Office of Land Management

August 1, 2024

Re: In the Matter of the Application of Xcel Energy for a Certificate of Need and Route Permit for the Mankato – Mississippi River 345 kV Transmission Line Project in Southeast Minnesota  
PUC Docket Number: E002/CN-22-532, E002/TL-23-157

**Figure 1**

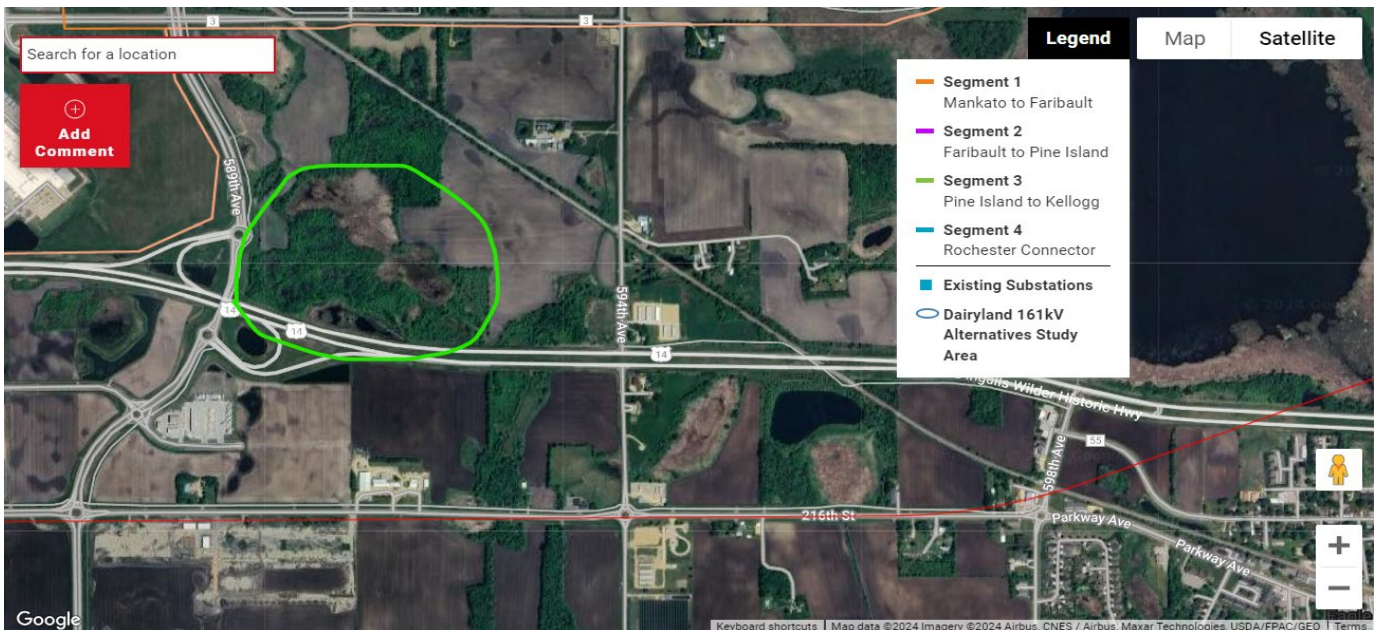
1. On the north side of US 14, there is a wooded wetland complex (Figure 1 below) with specific, prohibited actions including clear cutting of vegetation, material filling, water drainage, grade change, excavation and dumping. Placement of transmission line structures in proximity to wetlands must comply with all MnDOT requirements associated with wetland buffers as well as any requirements asserted through the US Army Corps of Engineer's Individual Section 404 permit associated with this wetland.
